UNITED STATES PATENT AND TRADEMARK OFFICE

10/617,166

Office Action Summary

DETAILED ACTION

FIG. 1A

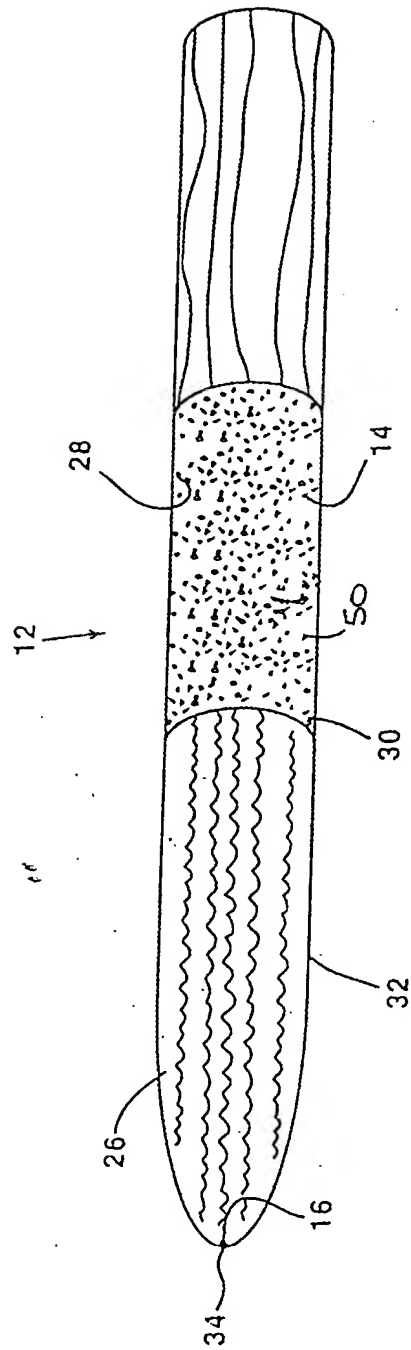
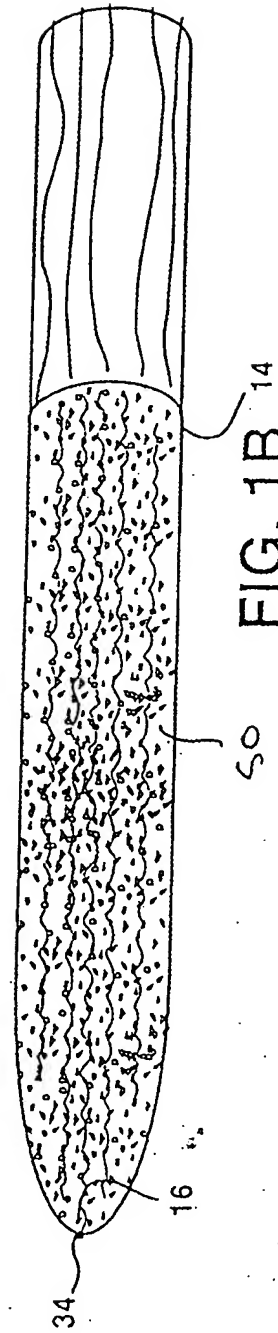
3. The drawings were received on October 3, 2006. These drawings are not accepted. The proposed drawings have an additional leader line from a new reference number 50 pointing to the medication in a dry, powdered form (Fig. 1A) or in combination with a reconstituting liquid (Fig. 1B). This appears to introduce new matter as the medication in a dry, powdered form or in combination with a reconstituting liquid is not an expelling material.
4. The drawings are objected to under 37 CFR 1.83(a). The drawings must show every feature of the invention specified in the claims. Therefore, the squeezable propellant chamber and the expelling material must be shown or the feature(s) canceled from the claim(s). No new matter should be entered.

disapproved
EKC 2 APR 2007

Corrected drawing sheets in compliance with 37 CFR 1.121(d) are required in reply to the Office action to avoid abandonment of the application. Any amended replacement drawing sheet should include all of the figures appearing on the immediate prior version of the sheet, even if only one figure is being amended. The figure or figure number of an amended drawing should not be labeled as "amended." If a drawing figure is to be canceled, the appropriate figure

FIG. 4

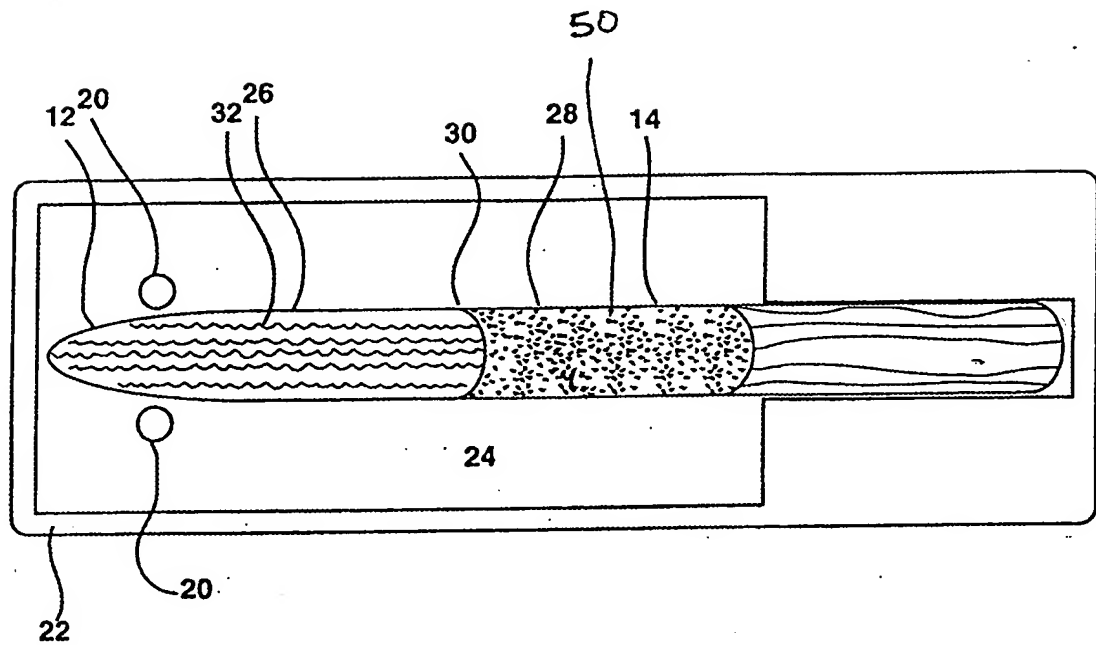
disapproved
EK 2 APR 2007
